APPEAL SUMMARY

Appeal ID: 23429	Project Address: 2400 NE Broadway St
Hearing Date: 2/5/20	Appellant Name: Joshua Klyber
Case No.: B-020	Appellant Phone: 5032091458
Appeal Type: Building	Plans Examiner/Inspector: Chanel Horn
Project Type: commercial	Stories: 1 Occupancy: A-2, F-2 Construction Type: V-B
Building/Business Name: Broadway Brewery	Fire Sprinklers: Yes - Throughout
Appeal Involves: Alteration of an existing structure	LUR or Permit Application No.: 19-248077-LU
Plan Submitted Option: pdf [File 1]	Proposed use: Brewery

NE BROADWAY BREWERY

PROPOSED SITE PLAN

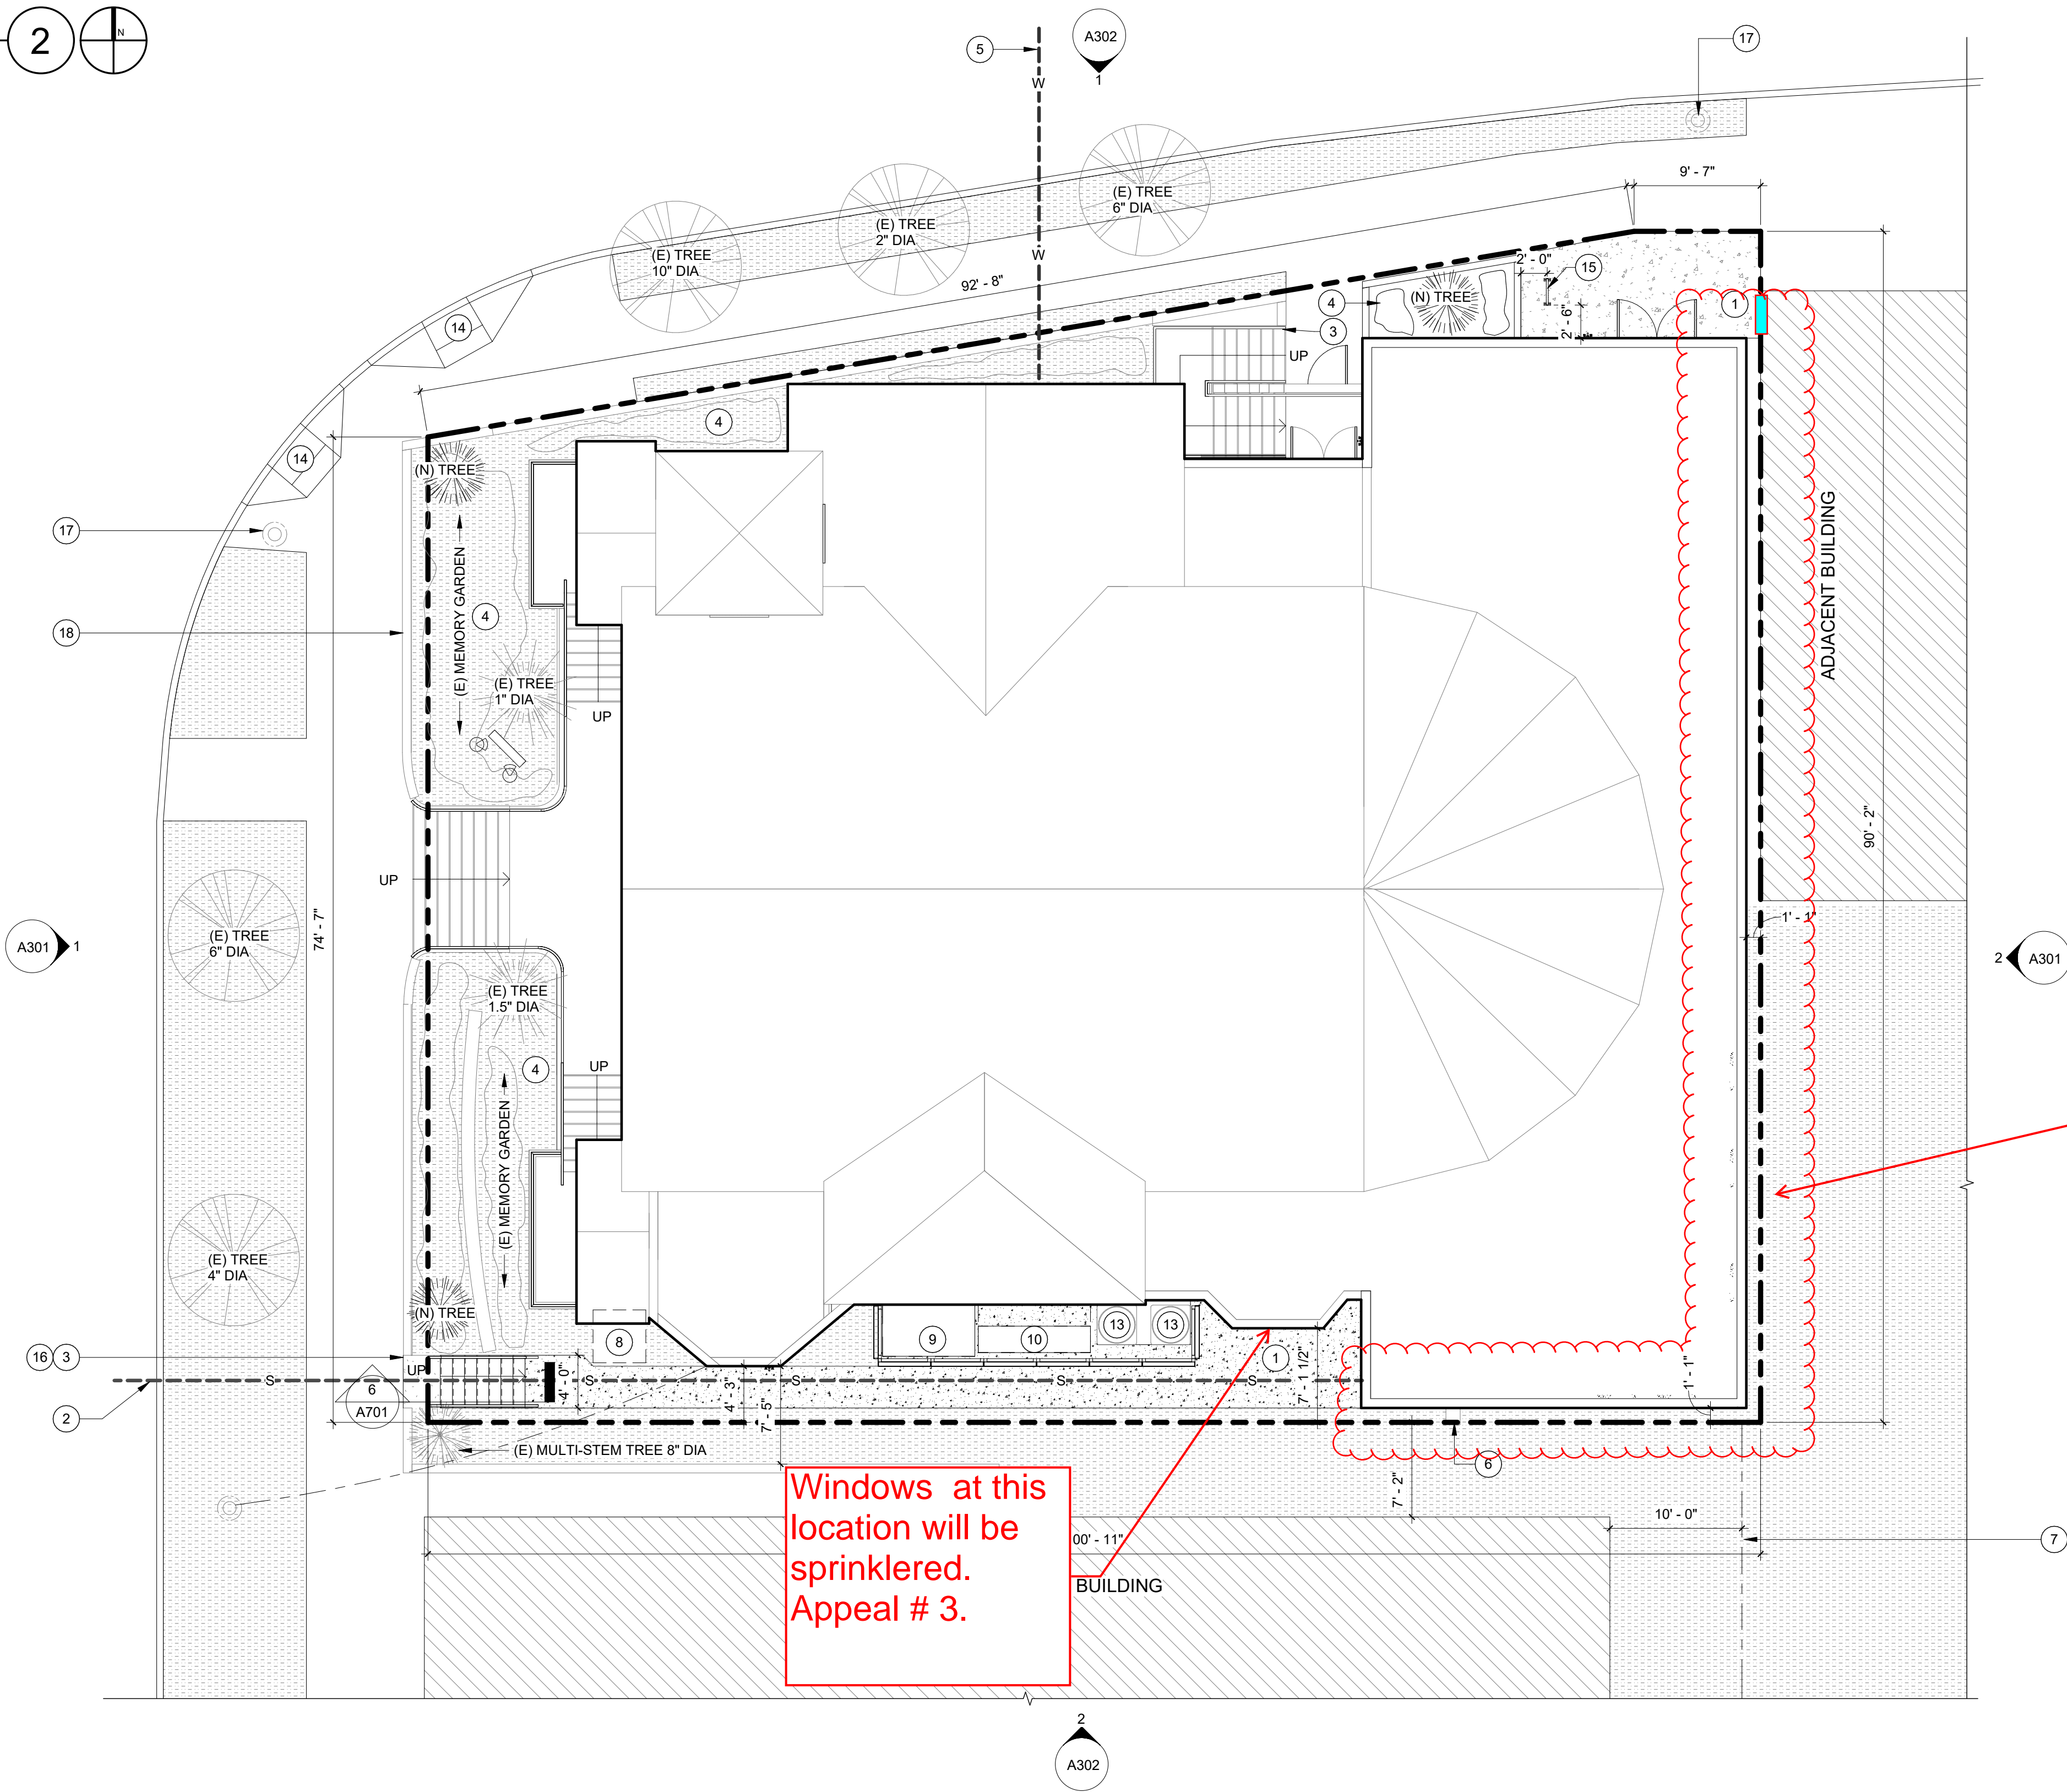
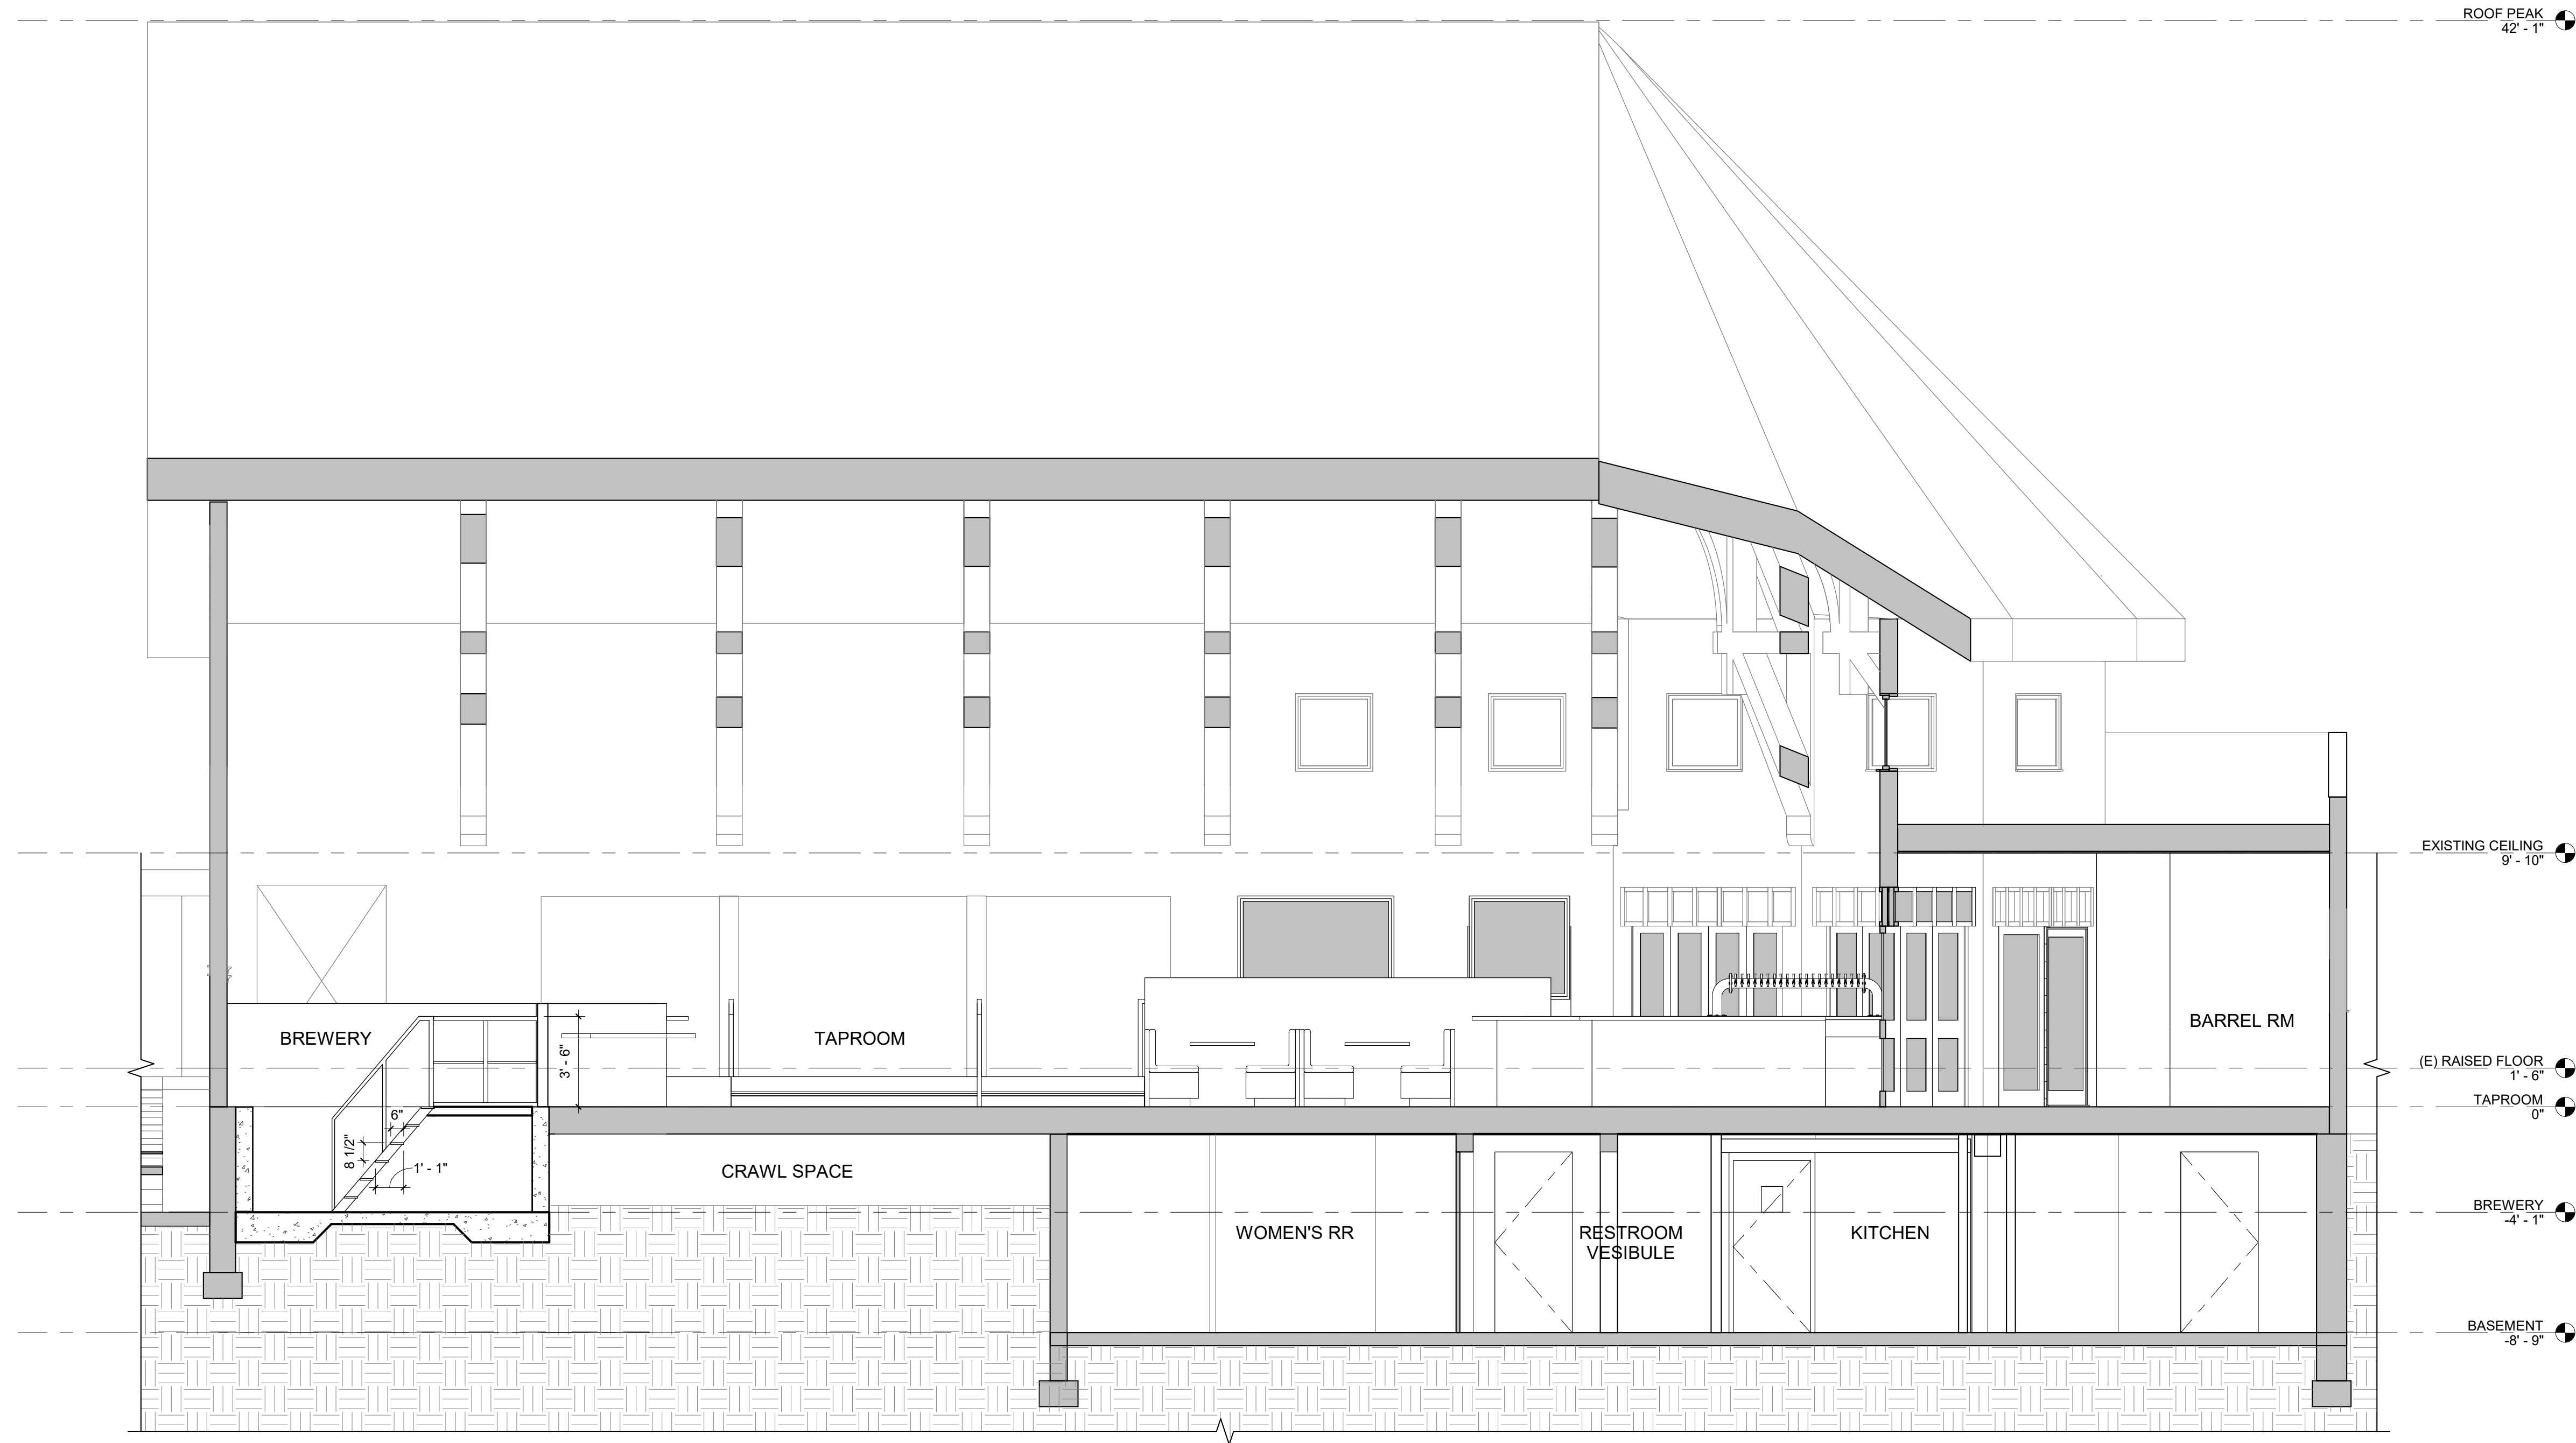
Proposed Design The Broadway Brewery is Type-VB construction and will be fully sprinklered. The east façade of the building is located one-foot one-inch from the property line. A portion of the building on the south side is located one-foot one-inch from the property line. A separate portion of the south façade is seven-feet one-inch from the property line. All three (3) do not have adequate Fire Separation Distance to allow for existing unprotected openings per OSSC Table 705.8.

Proposed Design The Broadway Brewery is Type-VB construction and will be fully sprinklered. The egress court located on the south side of the property has a width of less than 10 feet. There are two (2) doors on the south façade which will have a ¾ hour fire rating which is prescriptively compliant with §1028.4.2. There are seven (7) windows on the egress court which are non-rated. All of these windows are fixed pane without mullions.

Windows at this location will be sprinklered. Appeal # 3.

Windows along these exterior walls will be sprinklered. Appeal # 2.

- 1. Use of ship's ladder to access brewery tanks: Hold for additional information.**
- 2. Type 13 water curtain sprinkler protection at non-fire rated openings in exterior walls where openings are not allowed: Denied. Proposal does not provide equivalent Life Safety protection.**
- 3. Type 13 water curtain sprinkler protection at non-fire rated openings in exterior walls of egress court less than 10' in width: Granted provided windows are non-operable, and sprinklers are spaced not more than 6 feet apart and placed a minimum of 6 inches and a maximum of 12 inches from the opening(s) and a maximum of 12 inches below the ceiling. Sprinklers are to be installed on the occupied side of the openings. A separate permit from the Fire Marshal's Office is required.**
- 4. Exemption from high hazard occupancy classification for grist milling system: Hold for additional information.**
